**Champlain Hudson Power Express ("CHPE")
Environmental Management & Construction Plan
Notice of Major Change**

Project: Champlain Hudson Power Express

Segment: 12

Notice Number: 054

PERMIT DRAWING NO. N/A
DRAWING NO. C-103

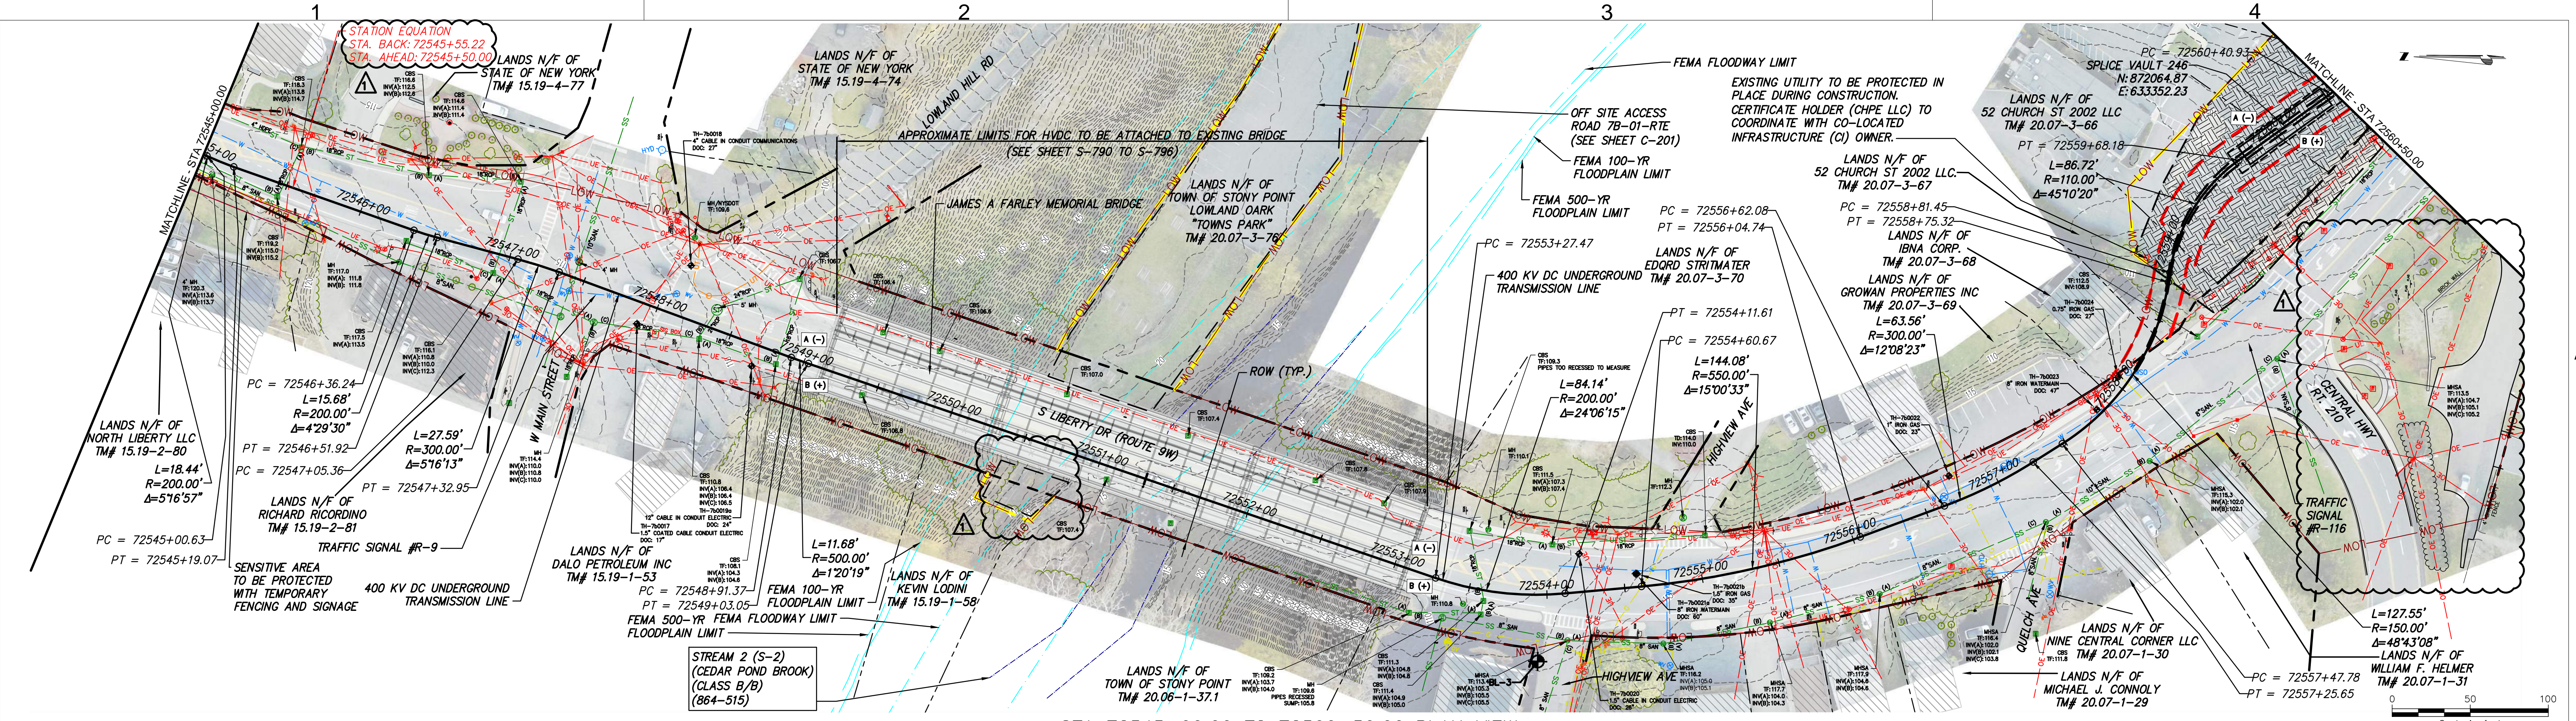
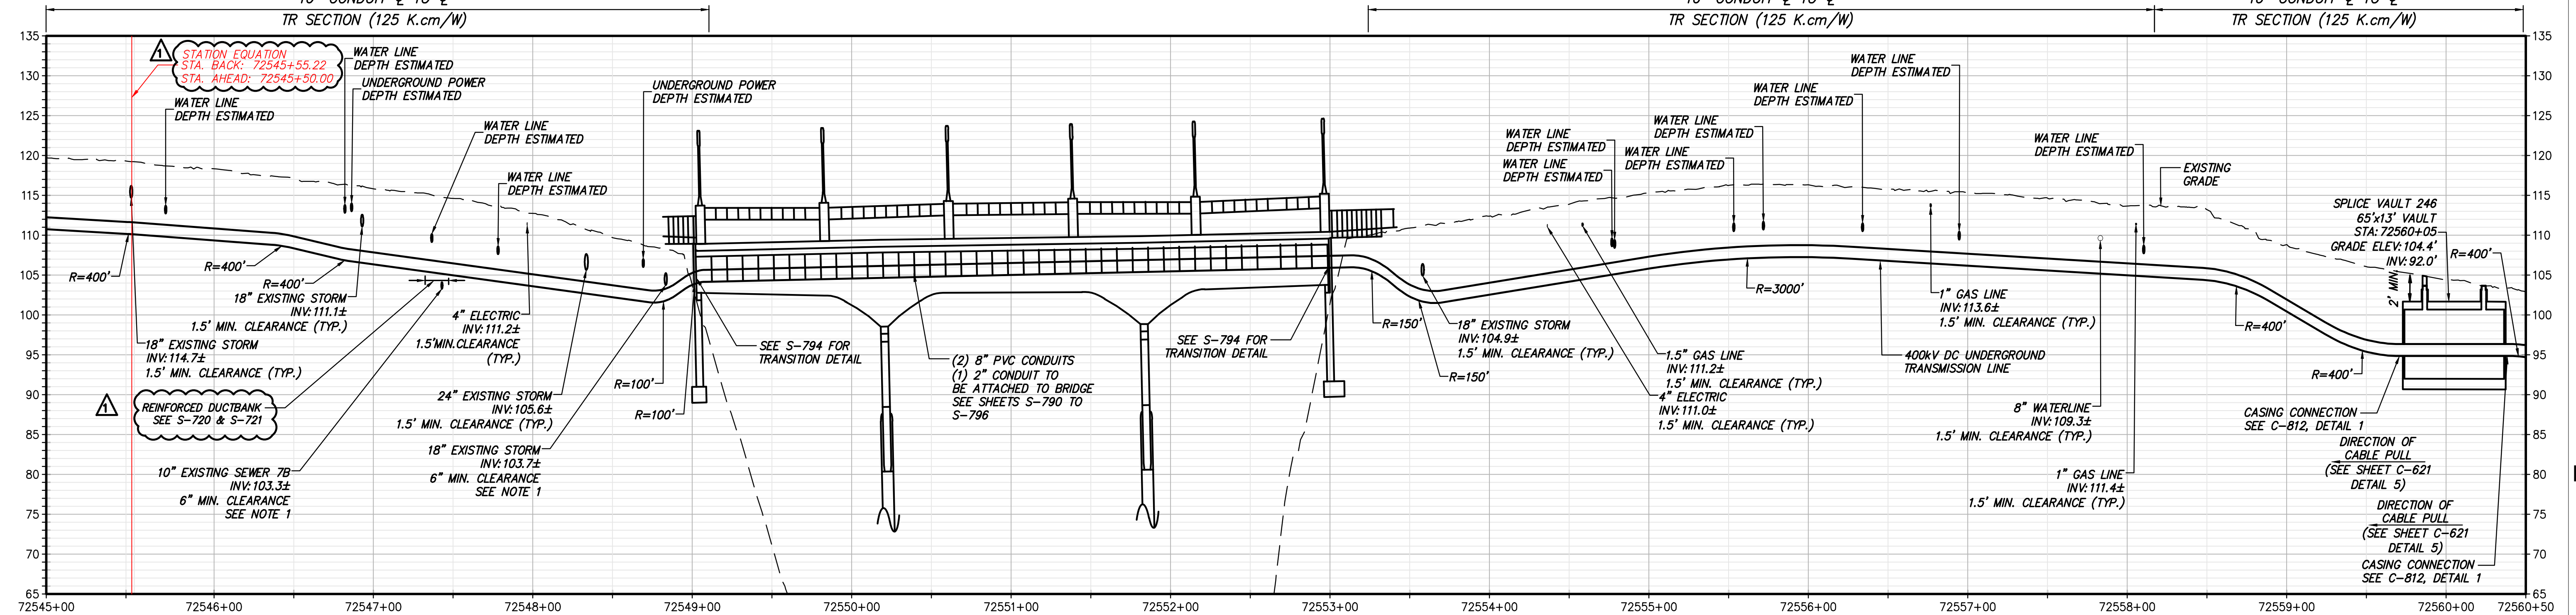
- A. Shifting of SV-245A:** This change involves a shift in the location of a vault, which results in portions of the alignment falling outside of the deviation zone in Segment 12. This change is intended to minimize impacts to an active business and maintain safety during construction. Coordination with this business owner revealed the need for additional space to ensure the business could maintain its access, parking, and other operational needs in close proximity to an active construction area, which proved to be more difficult than originally anticipated when developing the plans previously approved in the Segment 12 EM&CP. Having reviewed several alternatives with the owner of Liberty Beer (property of DC5855 LLC/; TM#15.19-2-67) to install splice vault # 245A in front of its business, it was determined that shifting the vault approximately 300ft south in front of Stony Point Fire District Wayne Hose Co. No.1 Station 1 building (property of Board of Fire District; TM# 15.19-2-76) was a more viable option. The Fire House has recently built a new garage facility for its fire trucks at the rear of the property and installing the vault at the proposed location would not impede its accessibility, operation, and emergency response. This property also offers sufficient room to install the vault without encroaching adjacent properties; and thus, minimizing disturbances to adjacent businesses and traffic.

- Notes from Orange and Rockland (Gas & Electric) added to sheet G-004.
- Location of additional soil borings have been added (Shts. C-101, C-103, C-106, C-107, C-109, C-112, C-118, C-124, & C-125).

- Consistent with NYSDEP request to install reinforced ductbank over all DEP regulated stream crossings to facilitate future improvement at those facilities, similar note has been added to all drainage crossings throughout this segment (Shts. C-101, C-103, C-104, C-107, C-108, & C-115).

This change would also require updating Deviation Zone Excursion # S12-3 of Table 1 of EM&CP "Appendix E Justification for Deviation Zone Excursions in Segment 12" to as below:

Excursion	Parcel ID	Location (Approximate – see Drawings for Details)				Justification for Revision	Environmental Impact Reviewed
		Sheet	Mile Point	Station Start	Station End		
S12-3	15.19-2-76	C-103	1.46	72541+41	72541+41	Splice Vault 245A	Cultural Resources; ESA 1; Wetlands; Terrestrial Ecology

PERMIT DRAWING NO. N/A
DRAWING NO. C-107

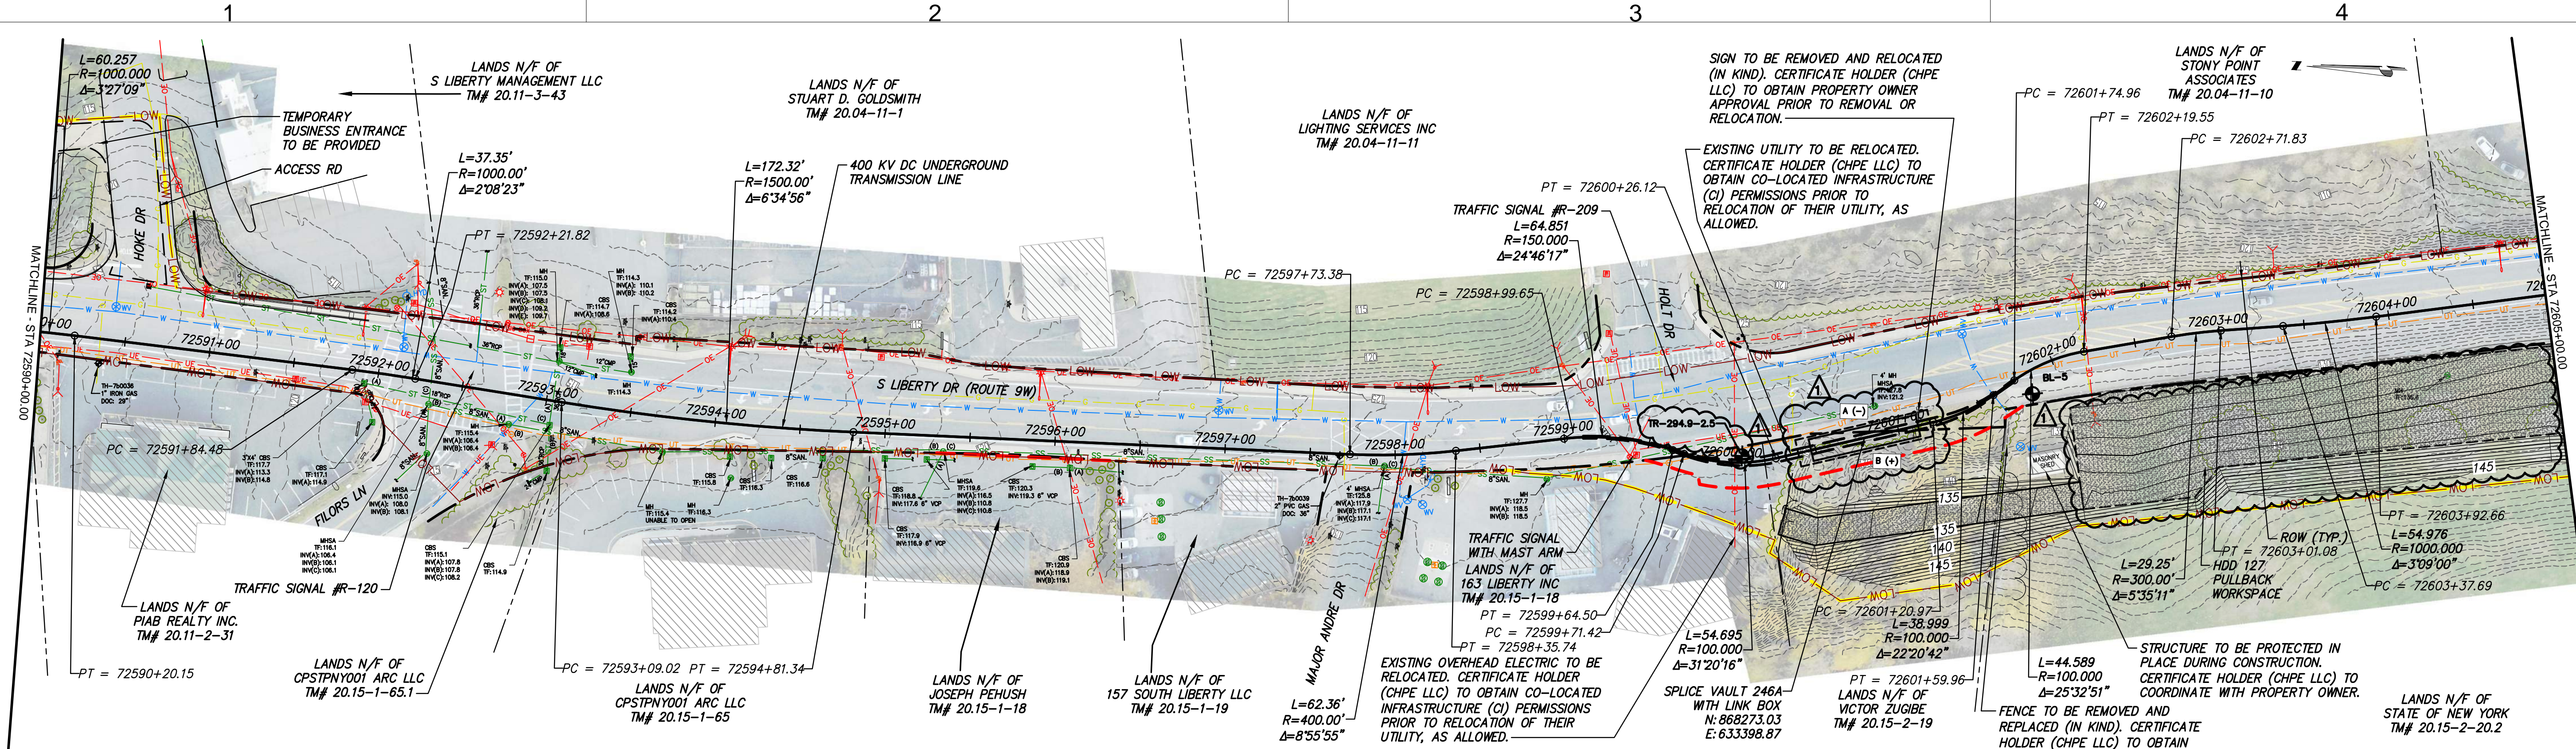
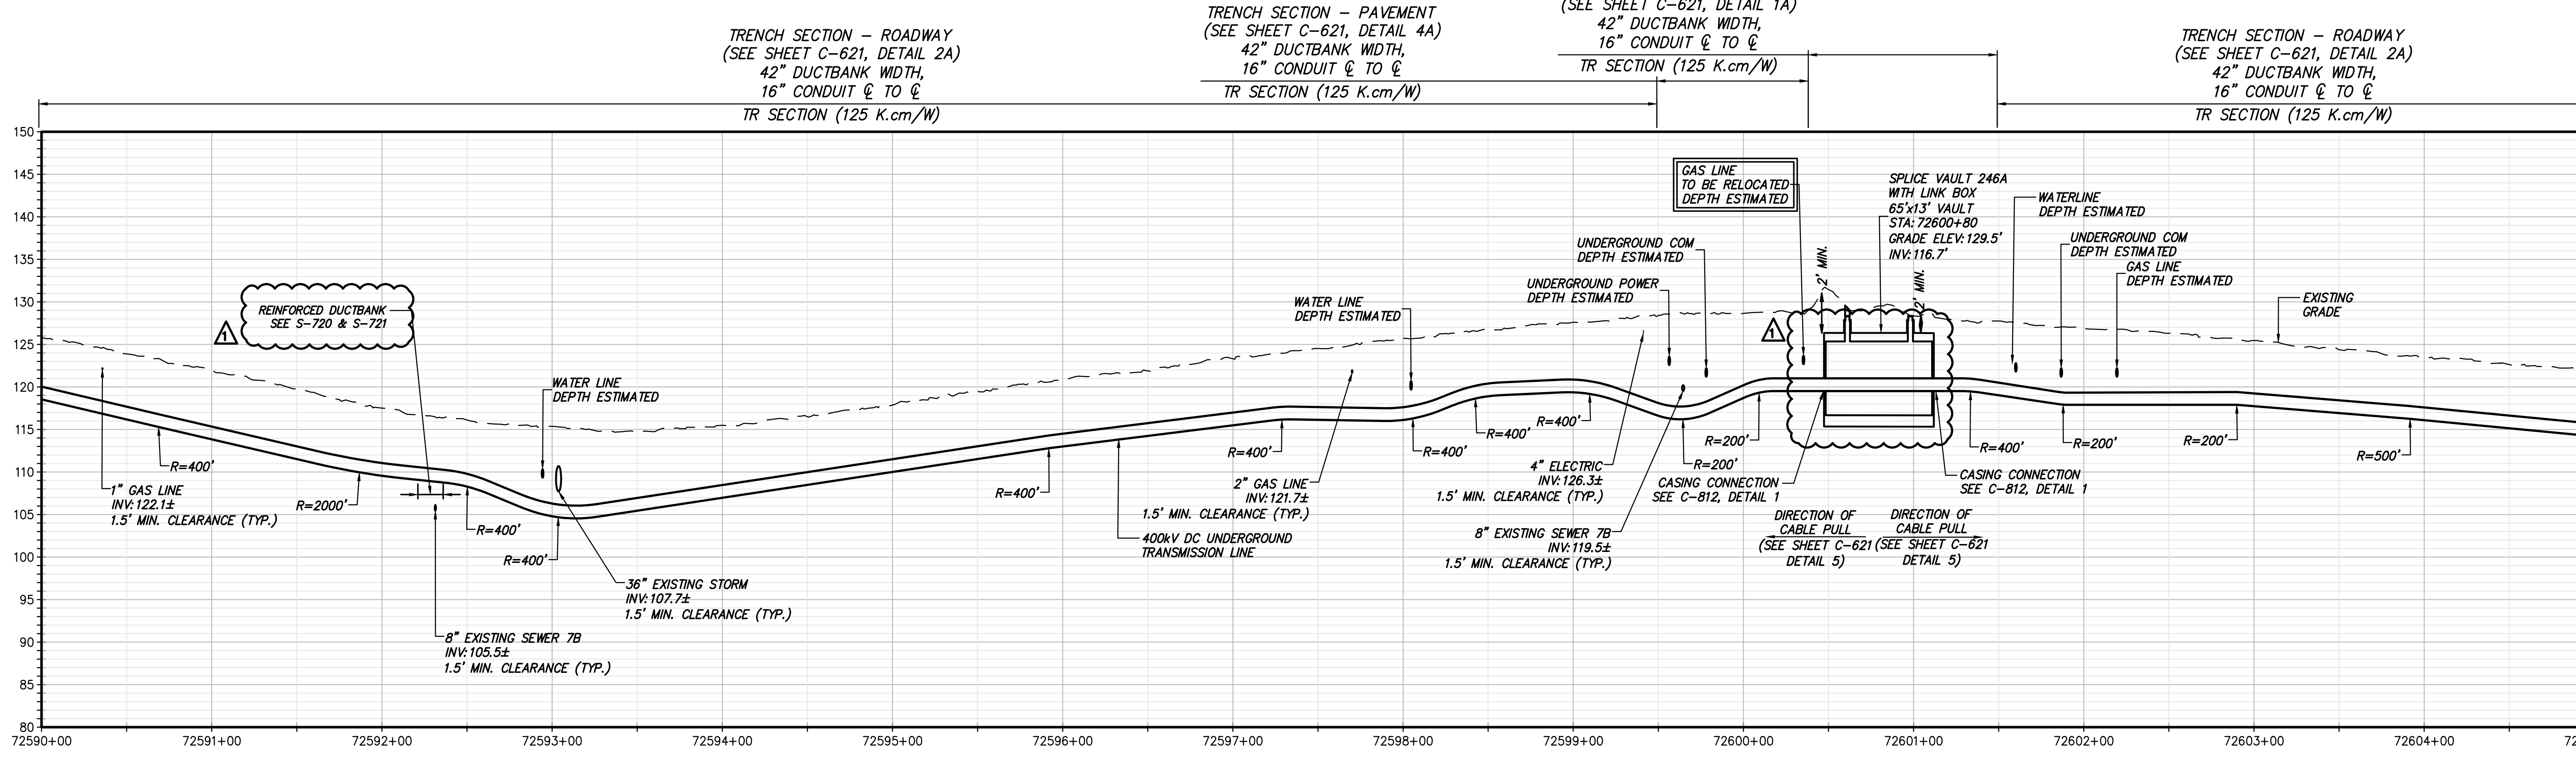
- As part of project wide cable length optimization, link boxes inside splice vaults have been revised (Shts. G-007, C-106 & C-107).
- Due to change in alignment as noted above, "Station Equations" have been added to the alignment stationing to minimize revising plan sheets not impacted by any changes (Shts. C-102, C-104 & C-108).

- Gravel hatching has been added to the temporary access roads and HDD work area (Shts. C-107, C-108 & C-202)
- Supplementary topographical survey information has been incorporated to the plans (Shts. C-102 & C-104).
